MANDATORY
SERVICE BULLETIN

June 2, 2016 Service Bulletin No. 366C

(Supersedes Service Bulletin No. 366B)

SUBJECT: Carburetor Throttle Body Screw Inspection

Figure 1
Illustrative Example of Throttle Body Attaching Screws

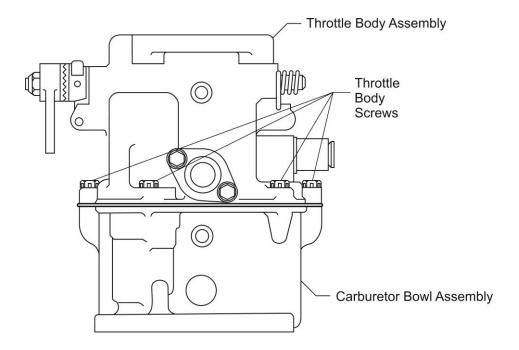
Instances have been reported of leakage through the gasket between the bowl assembly and throttle body of the carburetor, evident by fuel stains in the area of the leak. Leakage of this type can be accompanied by loose screws that attach the bowl and throttle body.

See Figure 1 for illustrative example of the throttle body attaching screws.

- 1. Examine the carburetor for evidence of fuel stains on the outside of the bowl along the parting line.
- 2. Complete a check for movement between the throttle body and bowl.
- 3. Make sure each throttle body-to-bowl attaching screw is secure and not loose by attempting to move the screw and/or locktab washers with your fingers.

CAUTION: IF ANY ATTACHING SCREW IS LOOSE, DO NOT ATTEMPT TO TURN THE

SCREW WITH A SCREWDRIVER. IF YOU TURN THE SCREW WITH A SCREWDRIVER, IT COULD DAMAGE THE LOCK WASHERS AND INCREASE THE LIKELIHOOD THAT THE SCREWS WILL DECOME LOCSE.

4. If there is evidence of fuel stains, movement between the throttle body and bowl, or the throttle body-to-bowl attaching screws are loose then remove the carburetor in accordance with the applicable engine and airframe service manuals. Send the carburetor to a qualified repair station for troubleshooting and repair. Reinstall the carburetor in accordance with the applicable engine and airframe service manuals.
